PRAIRIE ISLAND NUCLEAR GENERATING PLANT

Response to NRC Questions Dated February 12, 2001

Prairie Island Response to NRC Follow-up Questions dated February 12, 2001 from the February 9, 2001 Meeting Regarding Unit 1 Steam Generator Eddy Current Test Results

Figure 1
Structural Limit³, EOC Allowable Limit and Physical Repair Limit Curves
for Axial PWSCC in Low Row U-bends

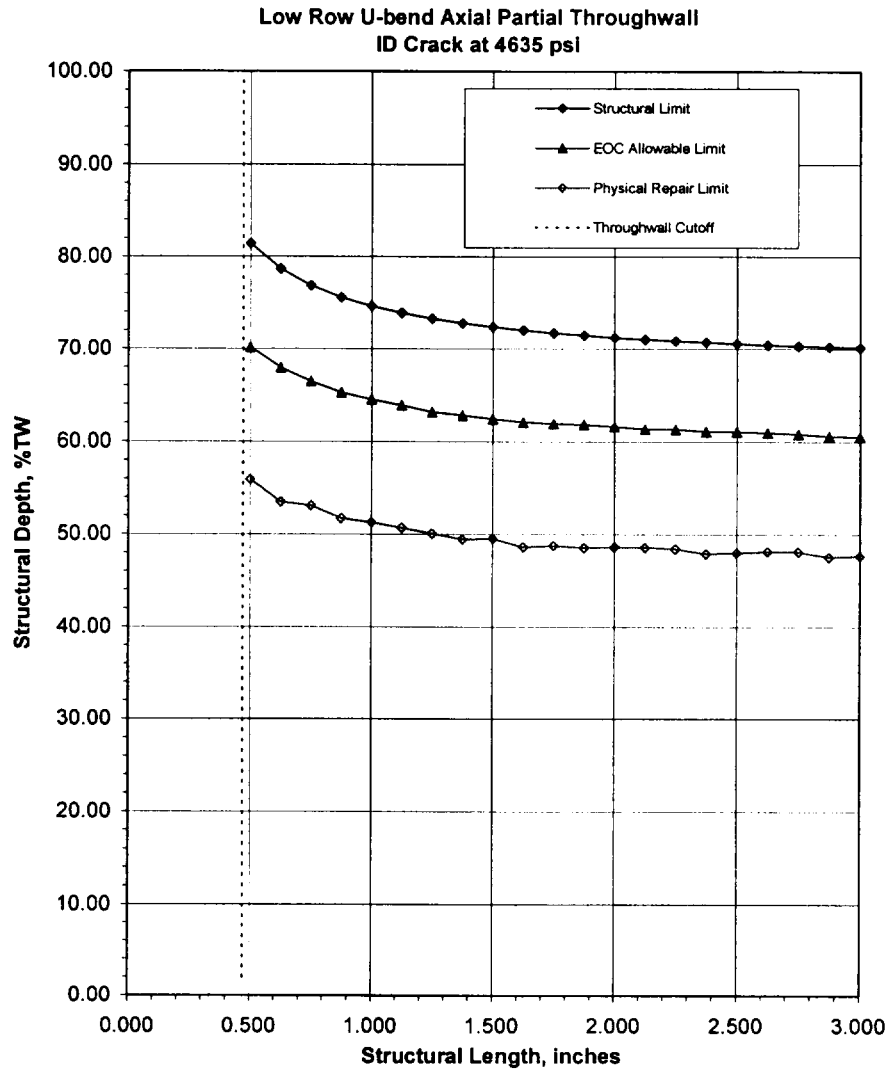
In the February 10 (sic), 2001 meeting, you presented two approaches to support a conclusion regarding minimum structurally significant flaws in terms of voltage. Provide an explanation of these approaches, the source and applicability of the data, the burst model(s) used, analyses performed, supporting assumptions, conclusions, and how you arrived at your conclusions.

Figure 1 shows a plot of the structural depth versus structural length for ID axial cracks leading to a $3\Delta P$ burst pressure of 4635 psi at 0.95 probability for the best estimate structural limit, the EOC allowable limit and the physical repair limit. The EOC allowable limit includes material property and burst equation uncertainty. The physical repair limit defines the limit of the actual physical dimensions of cracks which must be found to ensure that minimum $3\Delta P$ strength requirements will be met at the end of the next cycle. The physical repair limit accounts for crack growth over the next cycle of operation. Figure 1 shows that axial ID cracks in U-bends with average depths of about 50% TW must be found by inspection to ensure structural integrity requirements over the next cycle of operation. Historically, Prairie Island has detected indications meeting the physical repair limits of Figure 1.

The burst equation used in Figure 1 is taken from the EPRI Flaw Handbook (in final publication), Section 5.1.4, Part-through-wall Axial Cracking. It is based entirely on

The growth rate distributions used to construct Figure 1 are the same as those used in the Westinghouse/E-Mech CMOA analysis for Indian Point Unit 2 (Figure 5.5).⁵ The log normal distribution of average depth crack growth rates has an upper 95th percentile growth rate of 12.9%TW/EFPY and a median value of 3.45 %TW/EFPY. The length growth rate distribution meets or exceeds that used in the Indian Point 2 CMOA.

Figure 8
SG 11 Noise Levels – Mid Range Frequency

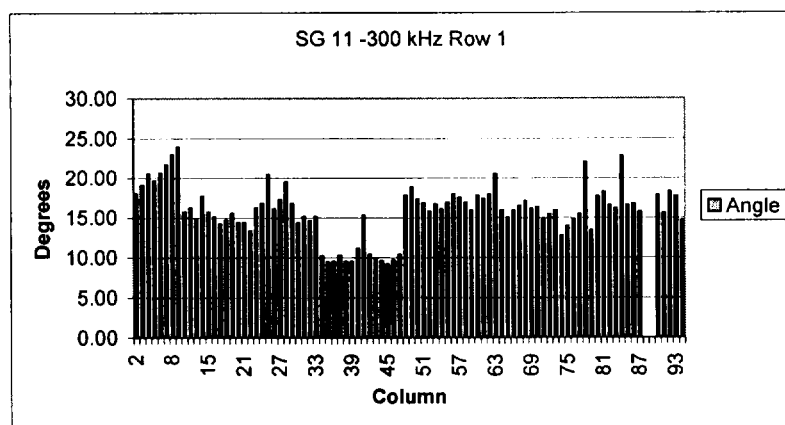
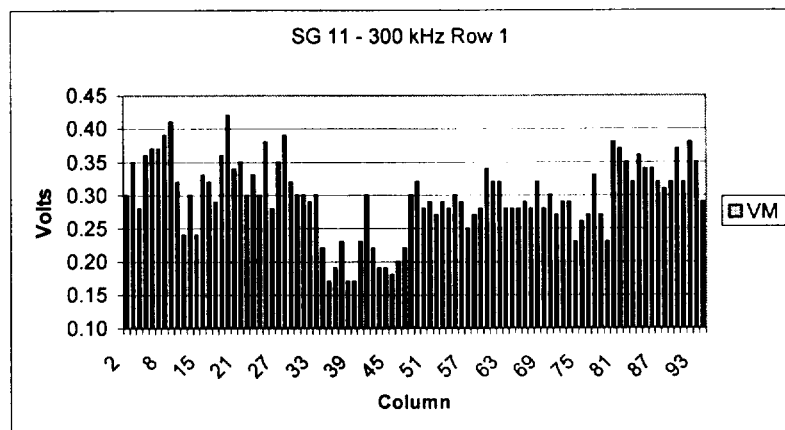
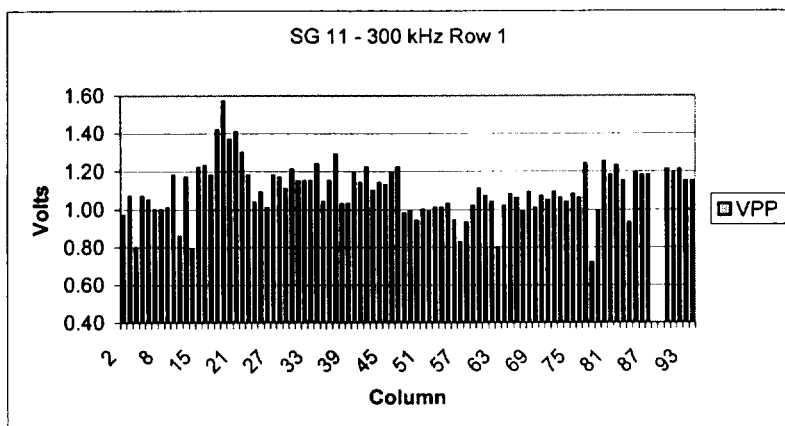
Discuss the criteria for reinspection and rejection of tubes, the basis for this criteria, and the outcome of all reinspections (e.g., changes in measured parameters).

11 SG contained the noisiest rows 1 and 2 U-bends. Figure 8 illustrates the noise levels in 11 SG row 1 U-bends. Those tubes exceeding the above noise criteria were retested with the high frequency probe. Figure 9 shows a decrease in the peak to peak noise levels. Also, Figures 8 and 9 include a plot of the phase angle calculated from the peak to peak volts and the vertical maximum volts for each tube.

Figure 14
Prairie Island Dents per Inspection Year, Grouped by TSP Location

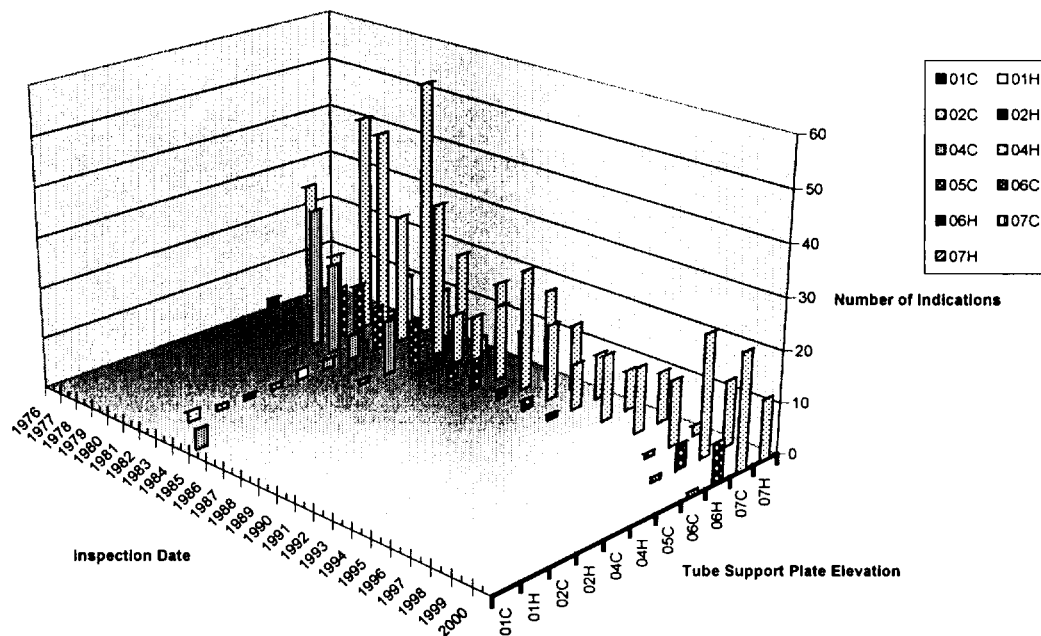
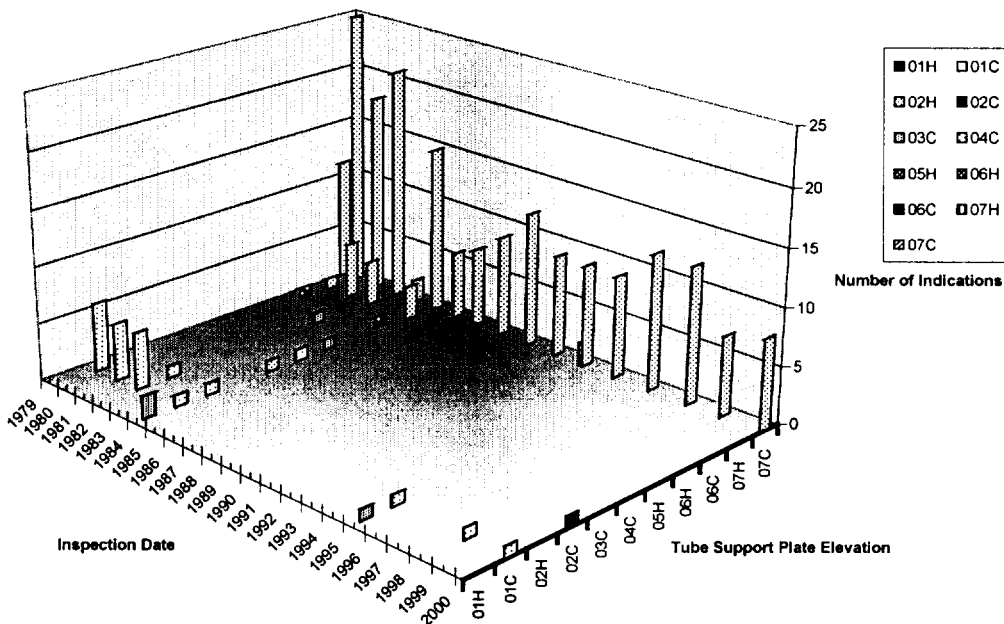
Provide a summary of the location and magnitude of tube dents that are in the PINGP, Unit1, steam generators. Discuss how the number and size of these dents has changed over time.

Figure 14 shows the trend of the number of dents at each tube support plate elevation, separately for cold leg and hot leg. No dents have been found lower than the 6th tube support plate since 1986. In the 2001 inspection, one of the dents is in row 6, the other nine are in the outer periphery beyond row 40 .

Figure 16
Drawing CR20011490

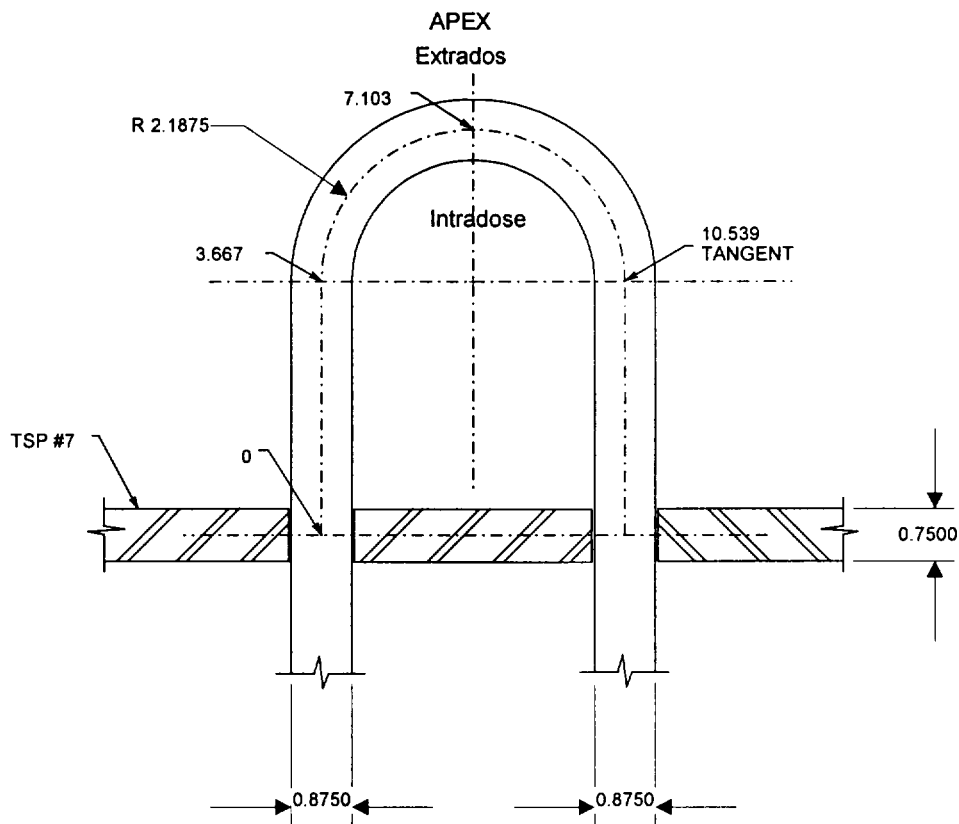
Provide a complete description of the location in the steam generators of the U-bend circumferential indications found in the February 2001 outage at PINGP.

Refer to Figure 16. The location of the circumferential indications (07H+~7.8 inches) is on the intradose of the U-bend about 0.7 inches from the apex on the cold leg side.

Figure 18
Eddy Current Data for EPRI U-bend Qualification Data Set: TVA-1

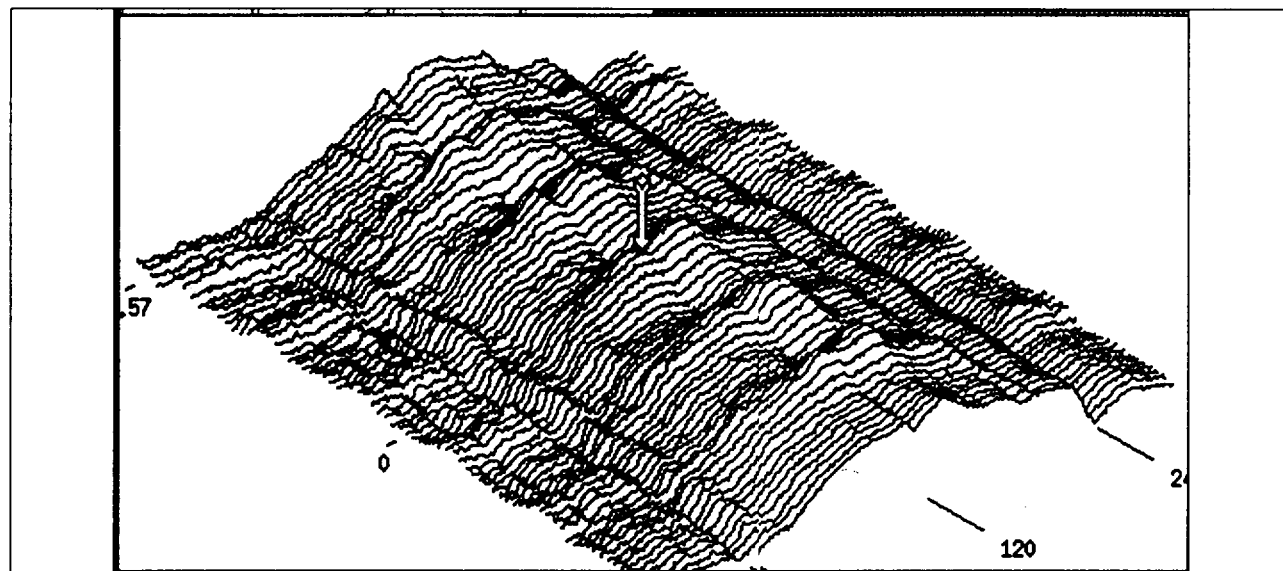
Discuss the results of your hindsight reviews of eddy current data performed on row 1 and row 2 tubes.

Figure 17 shows Prairie Island R1C52 eddy current data. Figures 18 and 19 show the eddy current c-scan of an EPRI U-bend qualification data set with horizontal ridges similar to R1C52. Thus, the horizontal ridges are not unique nor is a circumferential indication on the intradose of row 1 U-bend in the region between the two tangents. It is postulated that high stresses from the tube bending process physically change the intradose and the primary water stress corrosion cracks grow until high residual stresses are relieved. The ridges are due to the bending process.
